This CC91 letter is for door-ice (separator) assembly W10616146. This is being done in support of a service pointer W10749856 that applies to the issue of while a customer dispenses crushed ice, too much ice is being re-directed from the glass spraying out of the dispenser and to the floor. The correction is to replace current separator W10616148 with a new design. Once Customer Service determines whether the unit is a NON-IN-DOOR-ICE or IN-DOOR-ICE unit will help with the determination of the replacement separator assembly can be supplied.

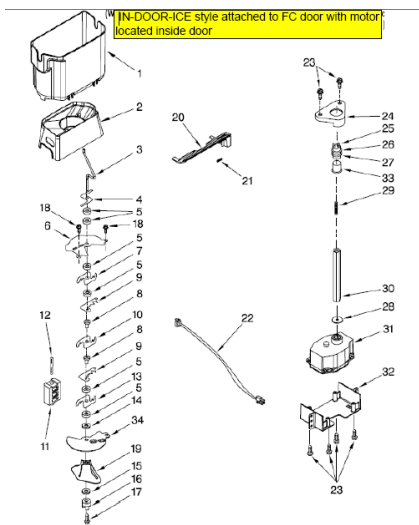
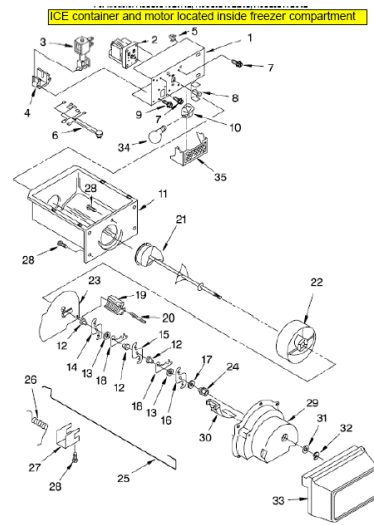
If the unit is a **NON-IN-DOOR-ICE** unit (ice bucket/container not mounted on the freezer door) the new replacement assembly will be the W10714978 –DOOR-ICE.

If the unit is an **IN-DOOR-ICE** unit (ice bucket/container mounted on the freezer door) the new replacement assembly will be the W10714973 –DOOR-ICE.
